WELL API NO.	30-045-28512
5. Indicate Type of Lease	STATE <input type="checkbox"/> FEE <input checked="" type="checkbox"/>
6. State Oil & Gas Lease No.	
7. Lease Name or Unit Agreement Name	
Santa Fe 20	
8. Well No.	5.
9. Pool name or Wildcat	
Gallup	
10. Elevation (Show whether DF, RKB, RT, GR, etc.)	
6576' GR, 6589' KB

Merrion Oil & Gas proposes to plug back the subject well to the Fruitland Coal as per the attached procedure. This is a change of plans from the original sundry proposing to P&A the wellbore.

Plug Back to Fruitland Coal Procedure

Well:	Santa Fe 20 #5	Field:	Fruitland Coal
Location:	1150' fnl & 720' fel (ne ne) Sec. 20, T21N, R8W San Juan County, New Mexico	Elevation:	6,576' GL 6,589' RKB
		By:	Connie Dinning

Merrion Oil & Gas Corporation
Wellbore Schematic
Santa Fe 20 No. 5
Proposed Wellbore Configuration

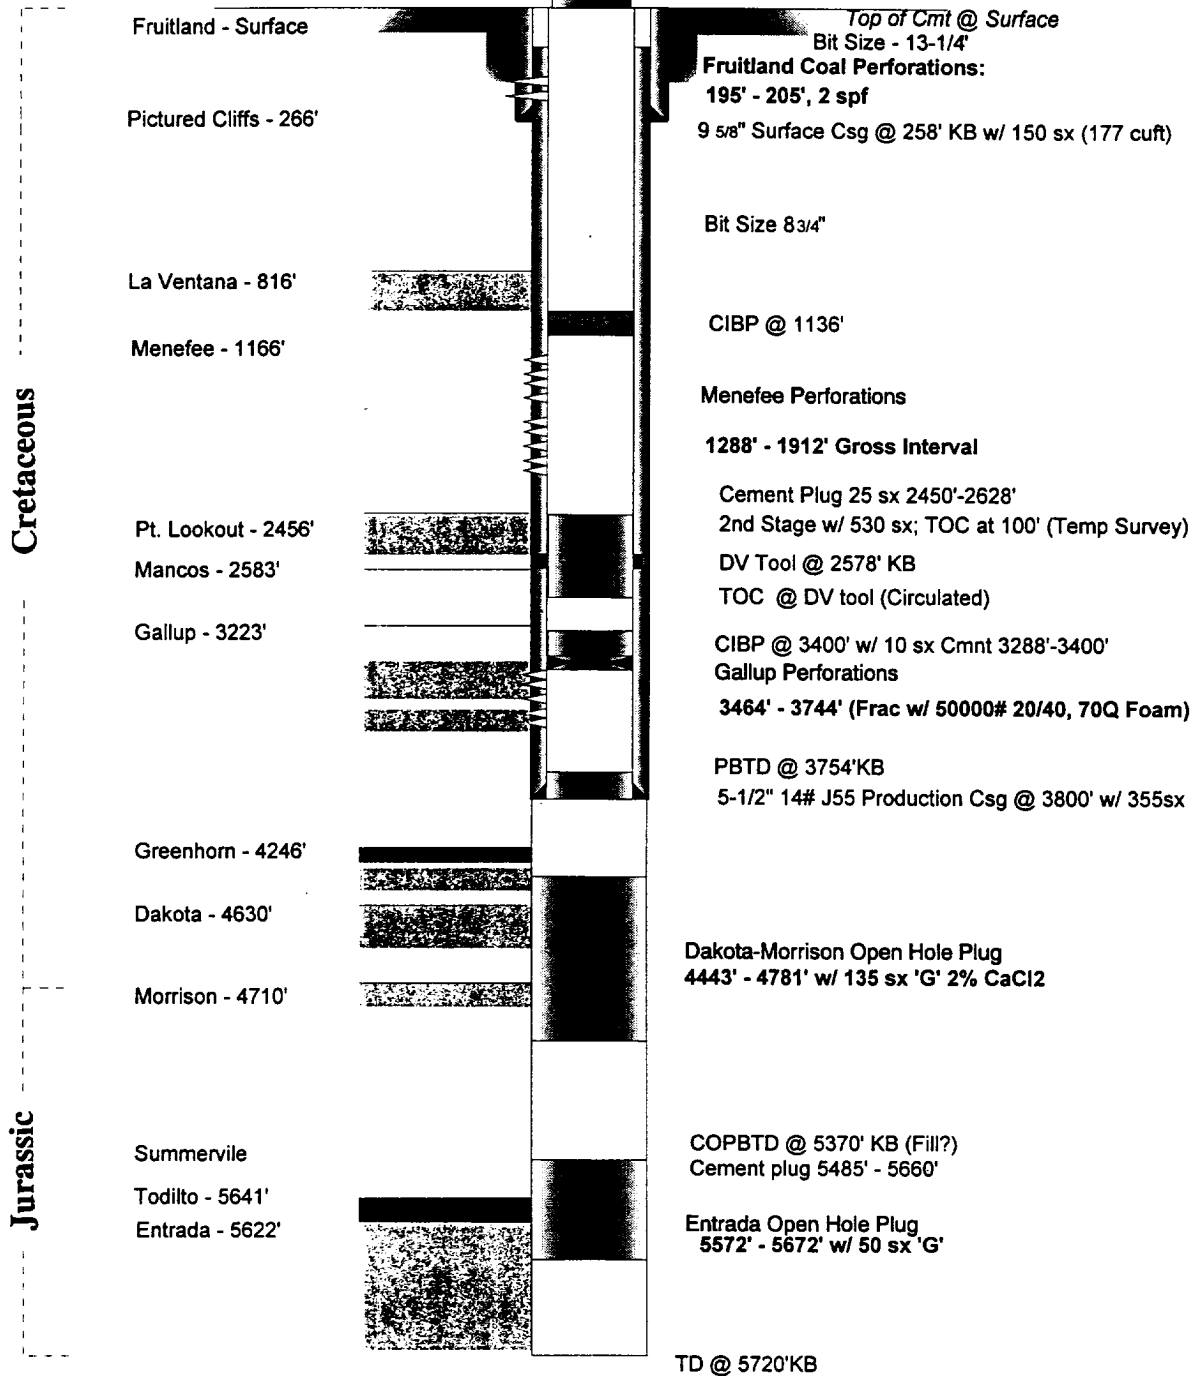
1. MIRU Petro wireline. RIH under lubricator and set CIBP @ 1136' KB.
2. Run GR, CCL and cased hole neutron log from 500' to surface.
3. RIH w/ casing gun and perforate Fruitland Coal through production and surface casing strings from, 2 jspf per neutron log (estimate perfs will be about 195' - 205').

1. MIRU JC Well Service.
2. ND WH, NU BOPs. RIH w/ 7 jts 2 3/8" EUE tubing w/ SN, set @ \approx 217' KB.
3. Swab well to unload and test gas production, evaluate need for further stimulation.
4. Put well on to production, RDMOL.
